**ADDENDUM NO. 02**

**DATE: 08/04/2023**

Clark/Mercedes Edwards Theater Remodel Phase 2  
Clovis, CA 93612  
Client Bid No: 2960

DARDEN PROJECT NO. 2215  
DSA File Nos. 10-27  
DSA APPL. NO. 02-121097

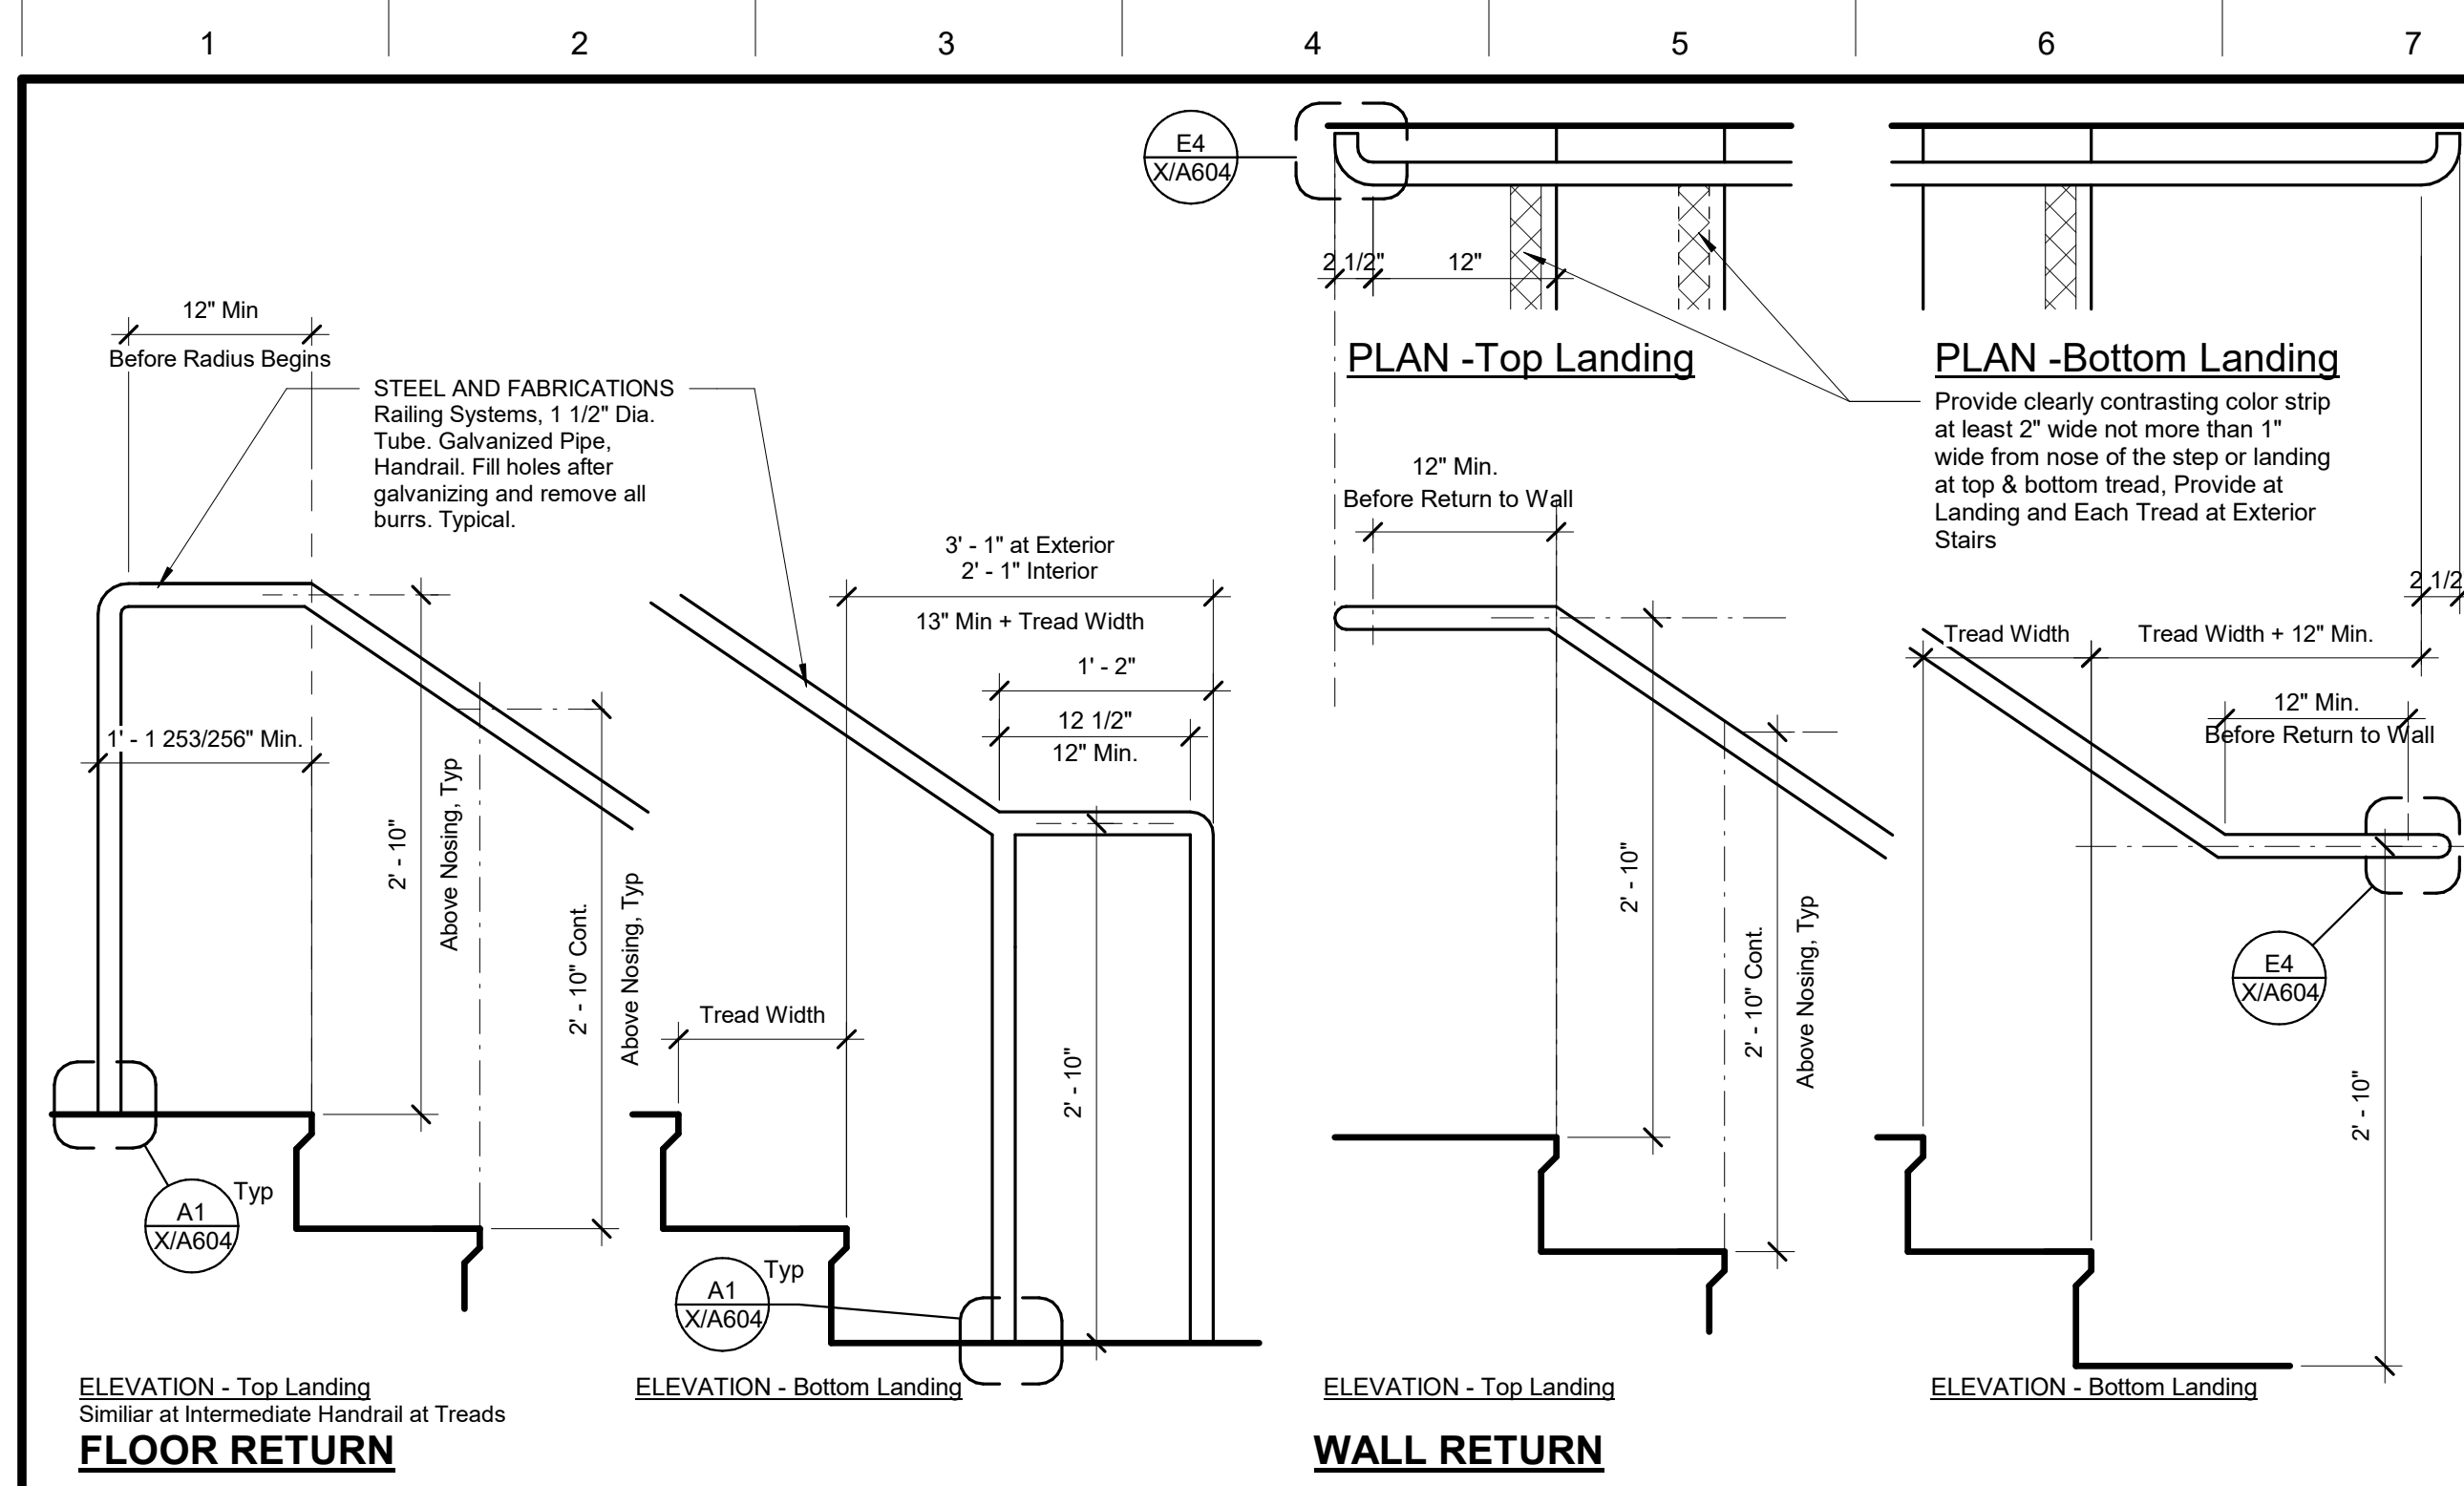
- AD02-A08 Refer to Sheet X/A412:**  
1. Details J11 and J14 updated. See attached sheet AD02-AX06.
- AD02-A09 Refer to Sheet X/A501:**  
1. Dimension fixed on Detail J11. See attached sheet AD02-AX07.

Designed By: Author  
 Checked By: Checker  
 Review/Approver: **T/A103.1**  
**AD02-AX12**

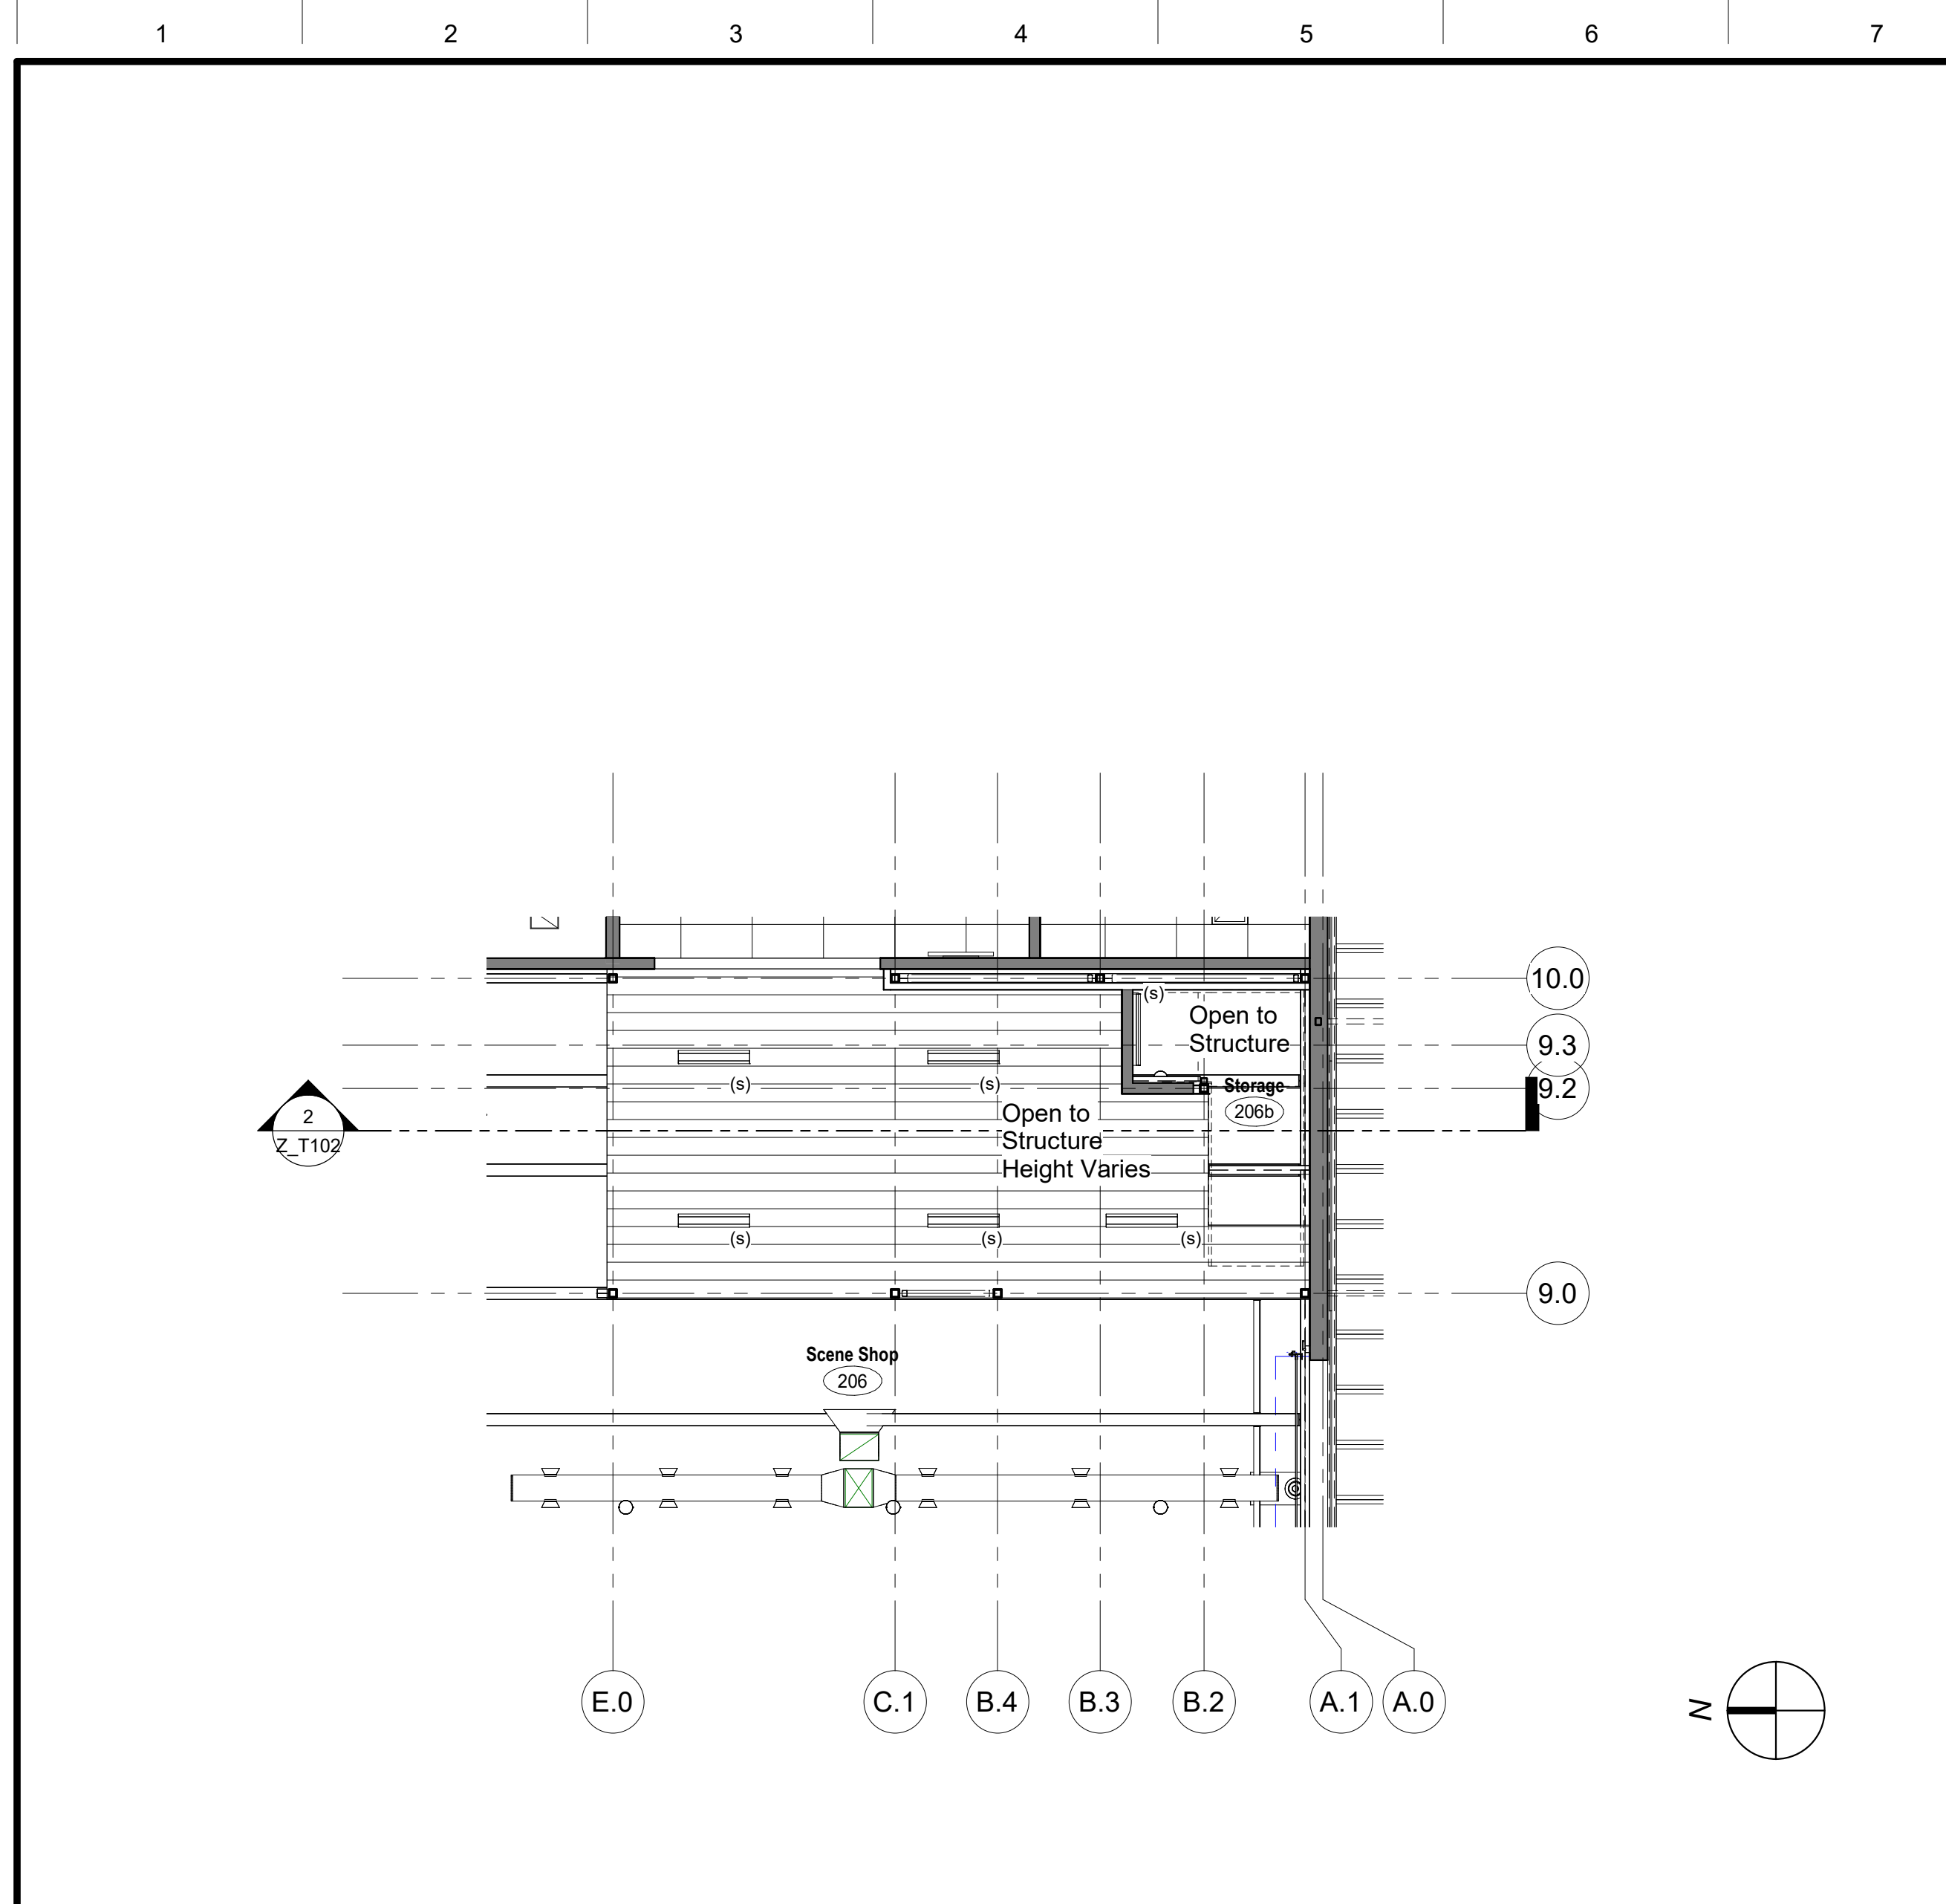
- AD02-A13 Refer to Sheet T/A102:**  
1. Added corner guard symbol to legend. See attached sheet AD02-AX11.
- AD02-A14 Refer to Sheet T/A103.1:**  
1. Added corner guard symbol to legend. See attached sheet AD02-AX12.

**T/S100**  
**AD02-SX01**

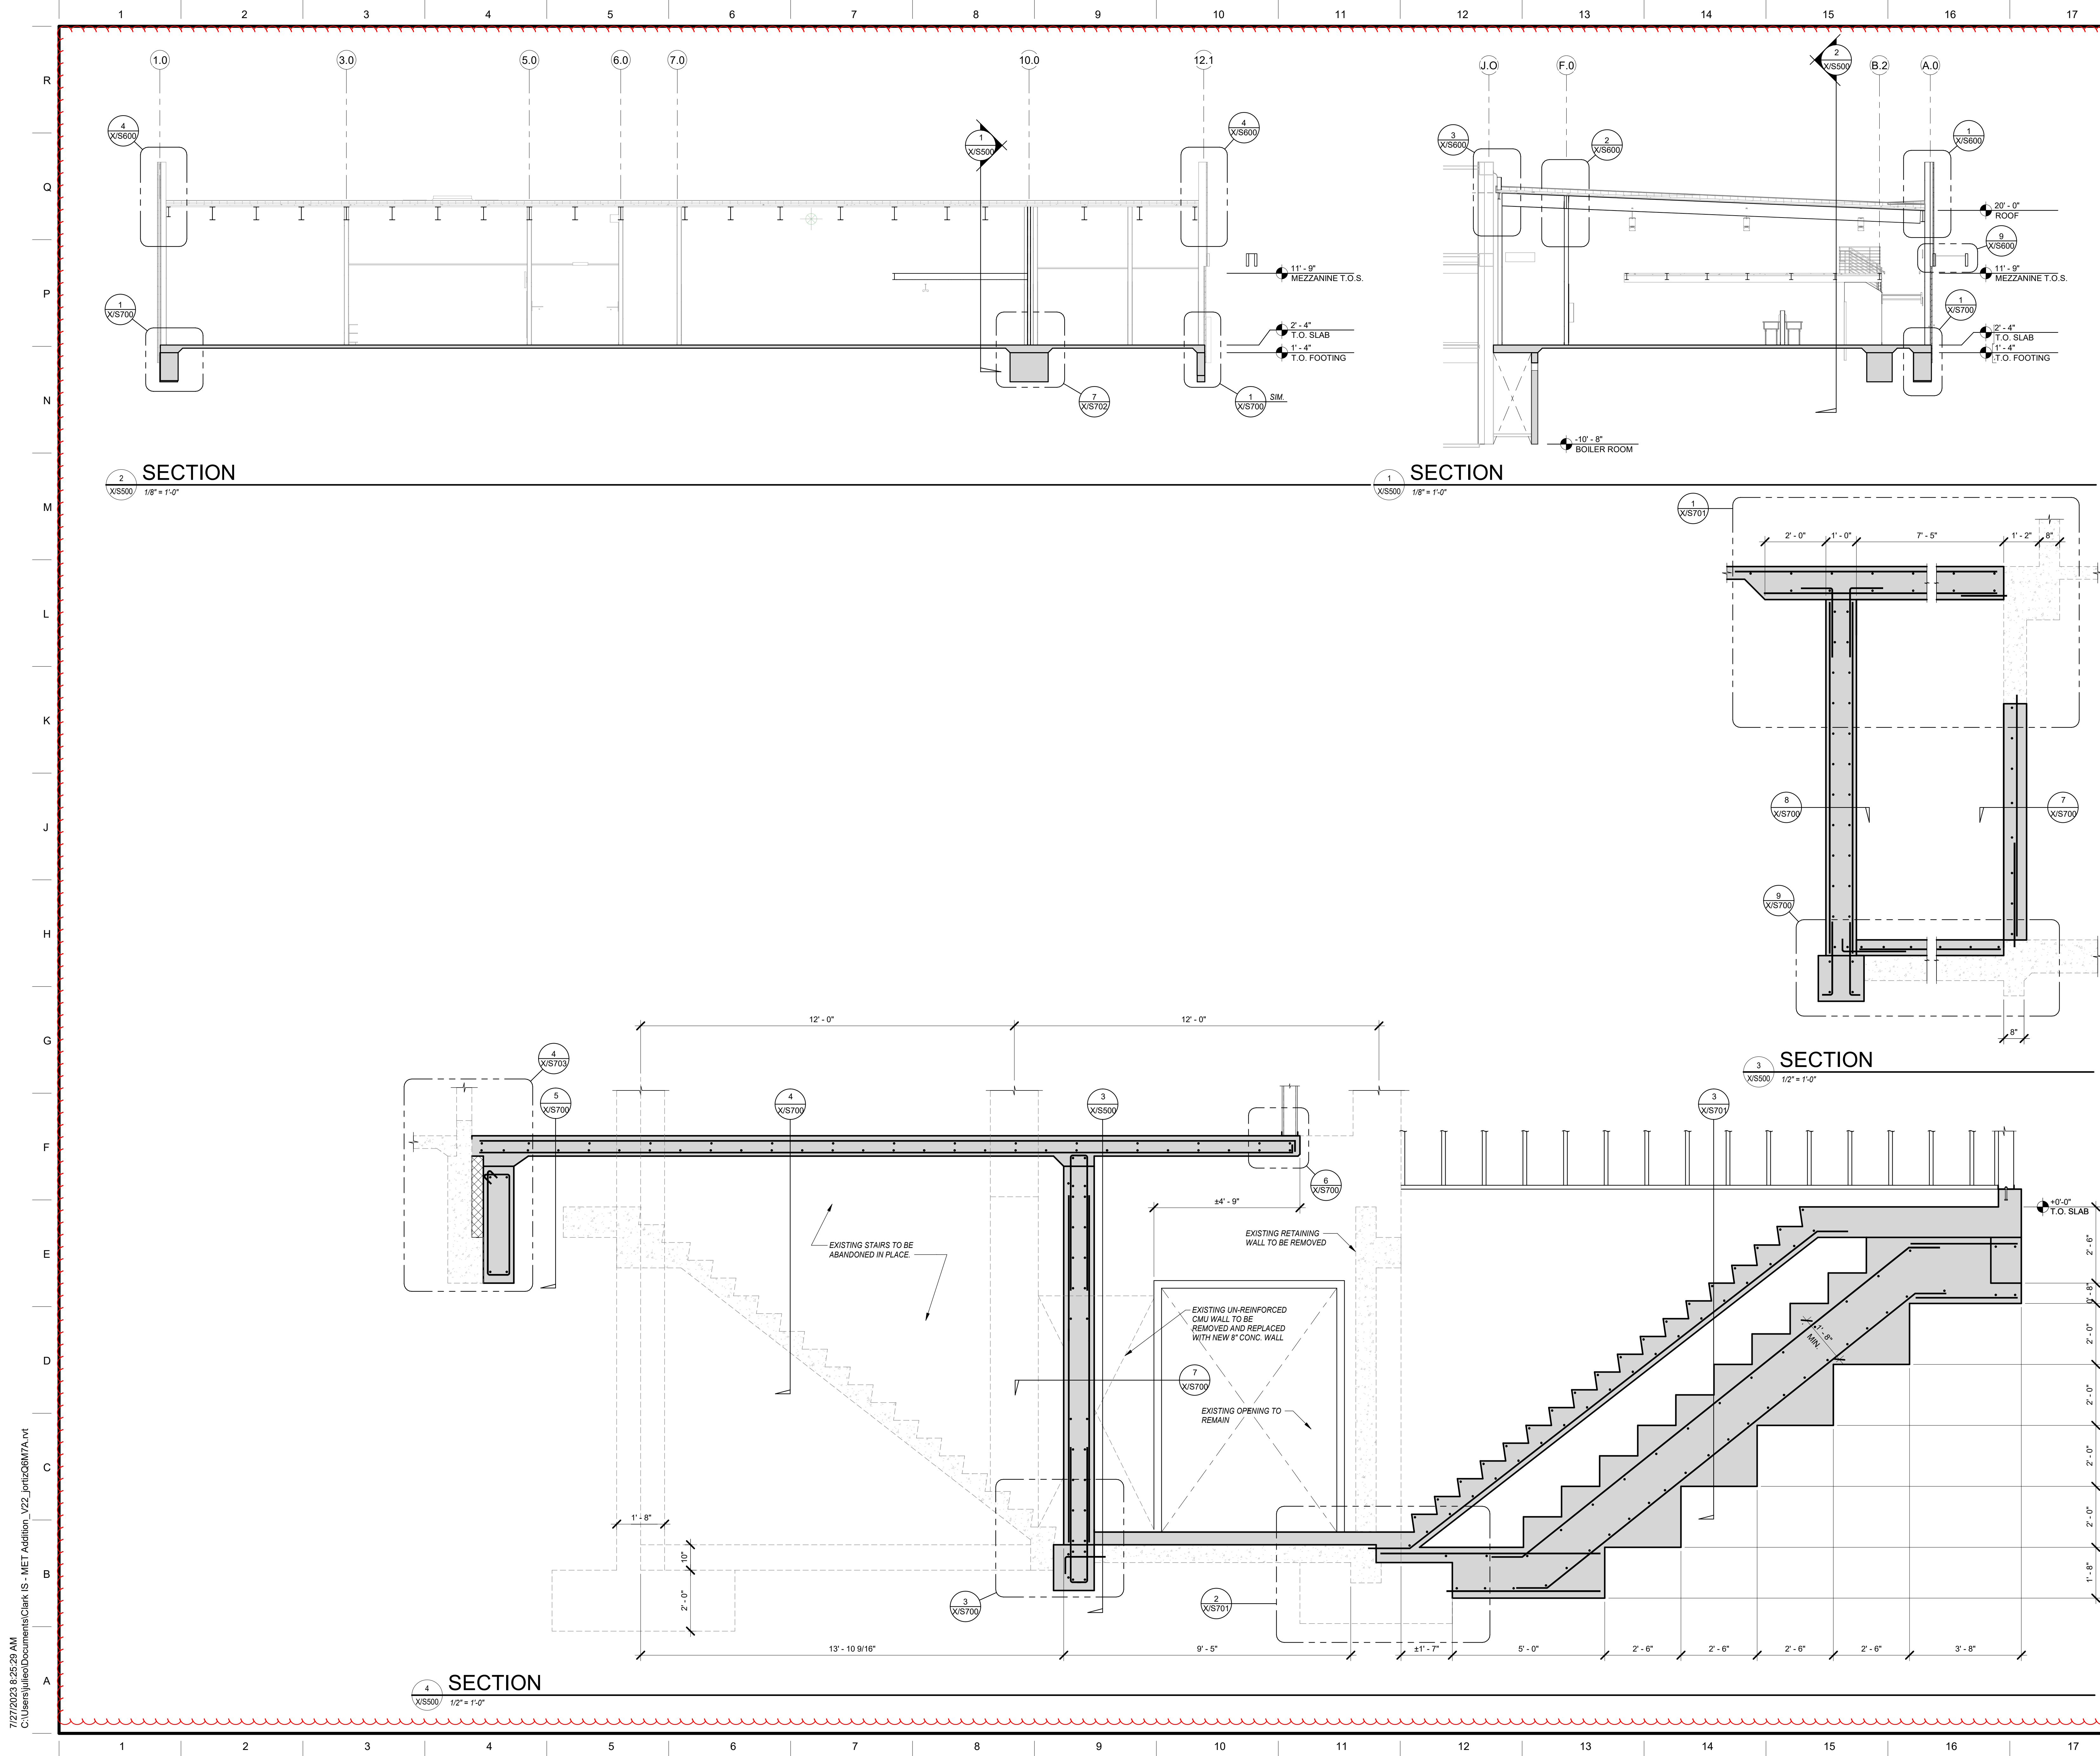
- AD02-S01 Refer to Sheet T/S100:**  
1. Remove and replace with attached sheet AD02-SX01. 1. A 3" recessed slab was indicated at the lift location at the west entrance. Size of the recess to be determined in accordance with manufacturer requirements.
- AD02-S02 Refer to Sheet X/S004:**  
1. Remove and replace with attached sheet AD02-SX02.  
i. Field weld of rebar for detail 8 was clarified.  
ii. Detail 10 was added for the housekeeping pad specification and anchorage of the boiler.
- AD02-S03 Refer to Sheet X/S500:**  
1. Remove and replace with attached sheet AD02-SX03. Section 4 was revised to indicate the foundation condition at the west end of the section.
- AD02-S04 Refer to Sheet X/S701:**  
1. Remove and replace with attached sheet AD02-SX04
